**APPLICATION FOR PERMISSION
UNDER SECTION 16 OF
THE TOWN PLANNING ORDINANCE
(CAP.131)**

For Official Use Only 請勿填寫此欄	Application No. 申請編號	A/YL-LFS/447
	Date Received 收到日期	24 OCT 2022

Response to Comment from Drainage Services Department

Comments on the planning application for the proposed Filling of Pond for Permitted Agricultural Use at Mong Tseng Wai, Lau Fau Shan (A/YL-LFS/447)

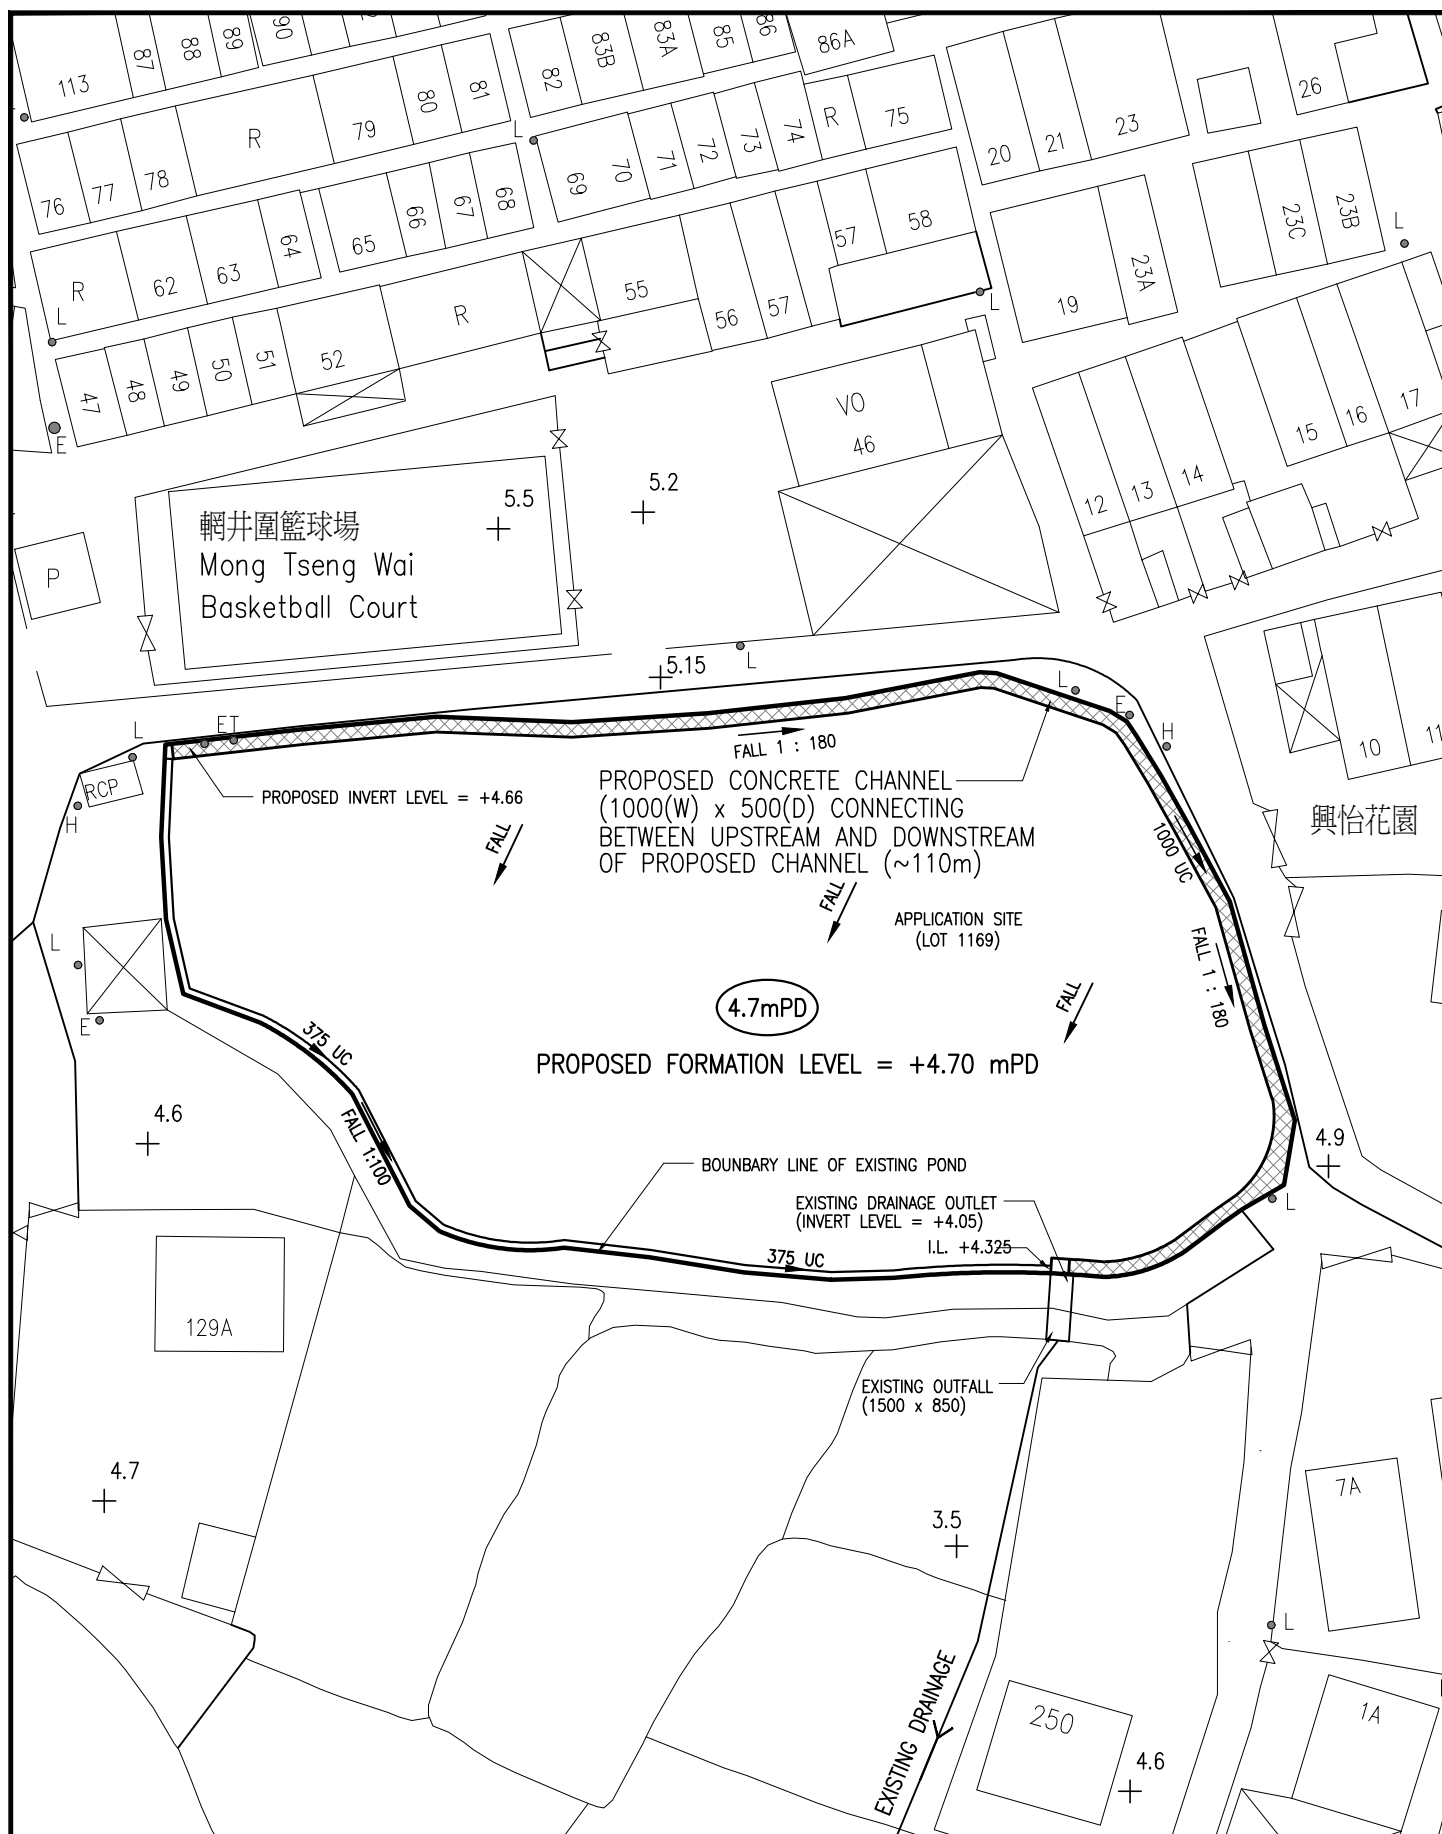
Comment	Response
The Applicant is required to firstly provide diversion proposal to the existing discharge.	See attachment “Existing Drainage Diversion Proposal (MTD02)” & Proposed Drainage Layout (MTW/SK002).
, and secondly, assess the effect to the area after the pond is filled.	See attachment “Existing Drainage Diversion Proposal (MTD02)” & Proposed Drainage Layout (MTW/SK002).

Refer to Drawing No. MTW/SK002, the alignment of proposed channel is indicated to suit for the proposed fill-up pond development. The proposed diversion comprise of 110m concrete rectangular channel. The channel size and the capacity check are as follows.

As shown above, the capacity of the proposed diversion (1.0m (W) x 0.5m (D) concrete channel) can provide full-bore capacity of not less than the existing pond capacity which can have 1 in 200 years protection level. Therefore, we conclude the proposed diversion is acceptable as there should be no adverse drainage impact to the drainage system due to proposed fill-up pond development.

Figure 1 Some pipe works (marked in red) surrounding the application site would be proposed for drainage purpose

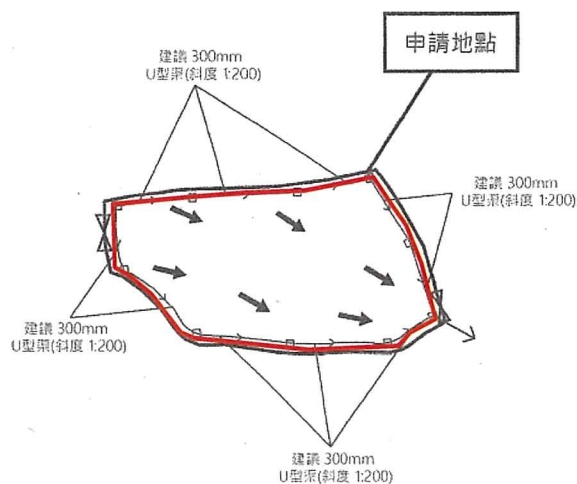
- Potential adverse drainage impact: The applicant does not provide any information to justify that overland flow from adjacent area would not be disrupted by the proposed pond filling and agricultural activities. We worry that the change of hydrology in the surrounding area would not only affect the adjacent village settlement, but also those fish ponds in the south of the application site, which is within the Wetland Conservation Area
- Potential impact brought by additional works: From Drawing 2, we would assume that some pipe works surrounding the application site would be

proposed for drainage purpose (Figure 1). However, we cannot see associated works such as land excavation has been mentioned in the application. Meanwhile, Drawing 4 did not mention what specific use or works would be proposed in the area just next to the area for agricultural purpose (Figure 2). We worry that all the above would cause both direct and indirect environmental impacts in the application site and its surrounding area.

From: [REDACTED]
To: tpbpd <tpbpd@pland.gov.hk>
Date: Thursday, 19 July 2018 2:30 AM CST
Subject: A/YL-LFS/325 DD 129 Mong Tseng Tsuen VillageOffice

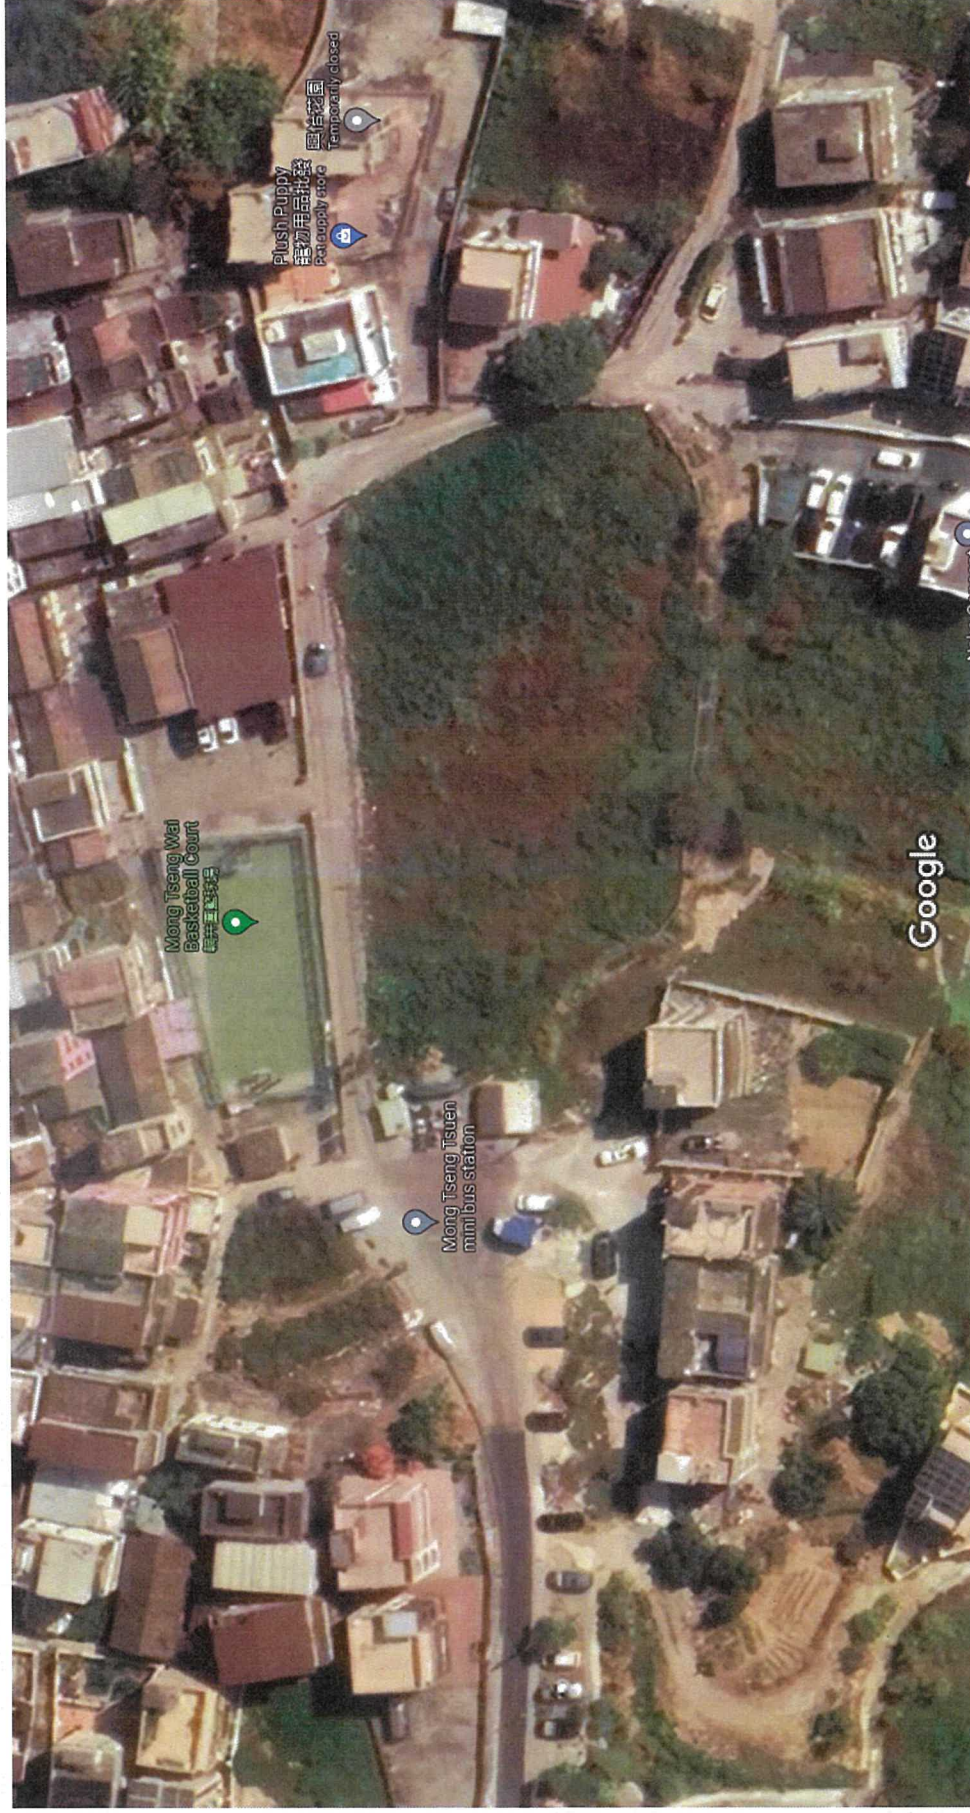
This is a very large office for a small community. It would take over land that could

accommodate 20 NET houses.

Members must question if this development would encourage applications to enlarge the village onto AG and GB sites in years to come under the excuse that there is no land left for village houses.
